Access Compliance Report

Public Rights-of-Way

Intersection ID: 13389	Main Street: ELIZABETH_AV	Cross Street: N_KINGS_DR	Location: N
ADA ID: 3AAFE78FB7ED	Ramp Type: PerpDiag	Initial Pass/Fail: Pass	Overall Compliance: No
		Severity Score: 0

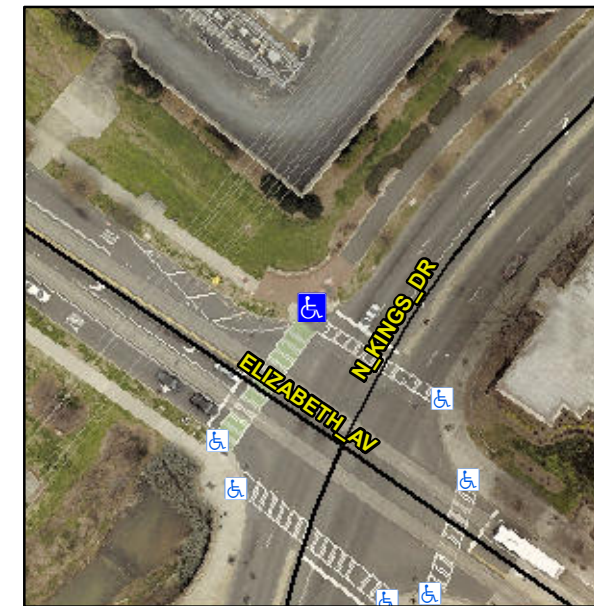
Not Found, R304.5.3, R305.2

Compliance	Description	Data	Compliance	Description	Data
N/A	Ramp Length (in)	96.0	Yes	Ramp Slope (%)	5.3
Yes	Ramp Width (in)	154.0	Yes	Ramp XSlope (%)	1.5
N/A	Flare Type LT	Sloped	N/A	Flare Type RT	N/A
N/A	Flare Slope LT (%)	2.0	Yes	Flare Slope RT (%)	3.0
N/A	Flare Traversable LT?	Yes	N/A	Flare Traversable RT?	Yes
Yes	Landing Length (in)	48.0	Yes	DWS Provided?	Yes
Yes	Landing Width (in)	154.5	Yes	DWS Contrast?	Yes
Yes	Landing Slope (%)	1.8	Yes	DWS Length (in)	24.0
No	Landing X Slope (%)	13.0	Yes	DWS Full Width?	Yes
N/A	Landing Curb? (Y/N)	No	No	DWS Offset (in)	6.0
N/A	Shared Landing?	No			
Yes	Gutter Ponding?	No	Yes	Gutter Slope (%)	2.7
Yes	Gutter Lip Ht (in)	0.0	Yes	Gutter X Slope (%)	0.6
N/A	Painted X Walk1?	Yes	N/A	Painted X Walk2?	Yes
	X Walk 1 Direction	To SW		X Walk 2 Direction	To SE
N/A	X Walk 1 Width (in)	136.0	N/A	X Walk 2 Width (in)	82.0
	X Walk 1 Slope (%)	0.8		X Walk 2 Slope (%)	0.9
	X Walk 1 X Slope (%)	0.7		X Walk 2 X Slope (%)	1.3

Remove & Replace Curb Ramp With Two New Directional Ramps or Equivalent.
